Illustrated Parts List - IPL Update

272XP

K 272
CRANKCASE

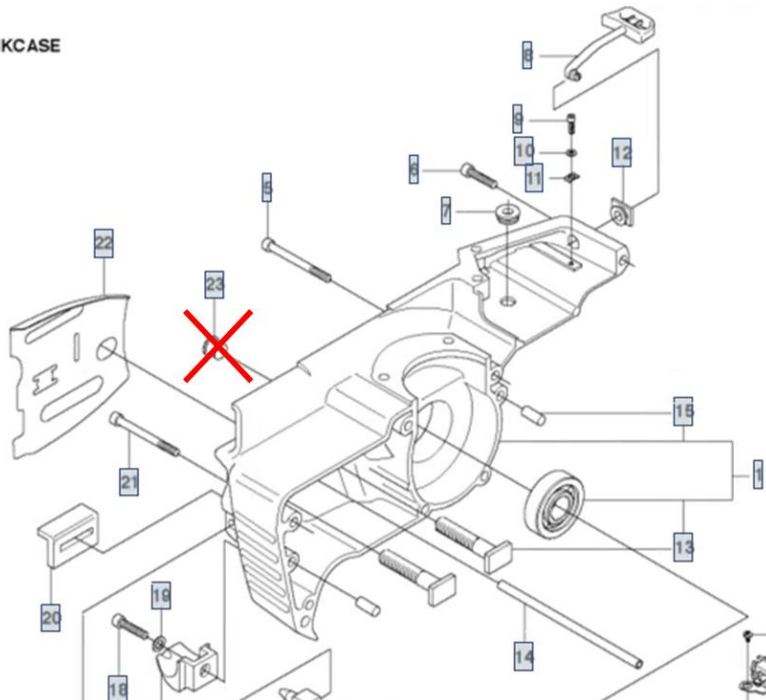
Removal of Plug 503 27 90-04.
Reason: The plug does not fill any function anymore.

Remove plug 503 27 90-04 (pos. 23).
